PLANNING BOARD REPORT PORTLAND, MAINE

Office and Retail Building
147-155 Washington Avenue
Level III Site Plan
2017-285
Diving Rock, LLC, Applicant

Submitted to: Portland Planning Board: Public Hearing Date: March 27, 2018	Prepared by: Shukria Wiar, Planner Date: March 23, 2018
---	--

Figure 2: Proposed Site Plan

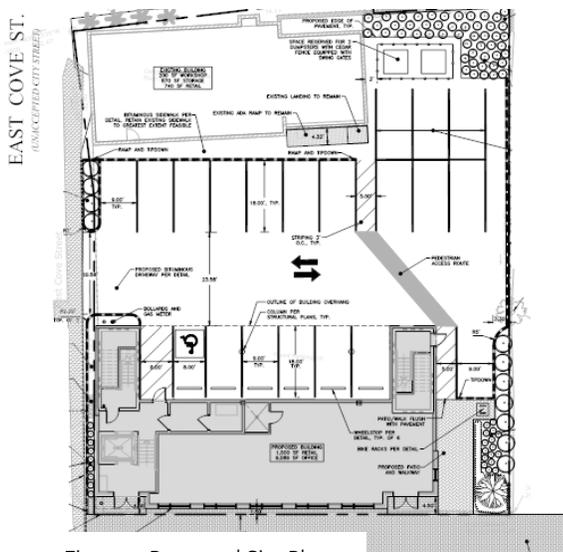
serve as the sole vehicle ingress and egress. East Cove Street is a vacated street by omission (accidentally not listed in the Council Order for unaccepted streets in 1997). The paved width of this street is approximately 28 feet, which includes an approximately 4-5 feet sidewalk. According to Tom Errico's review, access will be tight, but acceptable for vehicles. However, the Fire Department is looking at the access for public safety vehicles and is seeking a clear travel lane of 20 feet. The applicant's consultants are working with the city staff to develop a site plan that meets this standard. A more detail site plan will be available at the Board's public hearing.

a) Street trees - none proposed, would like to replace the missing tree and perhaps add a second one. The spacing would be between the proposed on-street parking spaces.

Rectangular shaped tree pit, with no tree grate or raised granite planter.

Recommended tree type ornamental due to overhead utilities, Species type include: 'Accolade' or 'Pink Flair' Cherry, or 'Adirondack' Crabapple.

b) Red Maple, on the right side of the building should be an upright shaped cultivar like, 'Armstrong' or 'Bowhall' Red Maple.

c) Landscape elements - Juniper virginiana (7) on the right side of the building, and on East Cove Street (4) these plants should be of a larger size then proposed 5 gal. Recommend 5 - 6' Height, 4 - 5' minimum.

Landscape planting near Dumpsters - the proposed treatment is 50 Panicum (Switch grass). It would be recommended to use perhaps 22 grasses in the snow storage area and include woody tree(s) or shrubs near the back of the dumpster for more year around and taller screening. Overall this space seems to have just a LOT of grasses as an easy fix vs optimize the space with some creativity and interest.

Staff has recommending and specifying the city's Bayside Medium (black) fixtures on Washington Avenue frontage. The landscaping plan will need to be revised to depicted one Bayside Medium LED street light fixtures on the frontage as requested by staff.

3. The applicant shall work with the Urban Designer to address the Design Review comments;
4. The applicant shall work with the City Arborist to address the landscaping recommendations and either include street trees in the final site plan or pay into the Street Tree fund; and

5. The applicant shall submit a final plan and specifications, for review and approval by the Planning Authority and the Department of Public Works, that are in conformance with the proposed LED fixture specifications for the street lights.
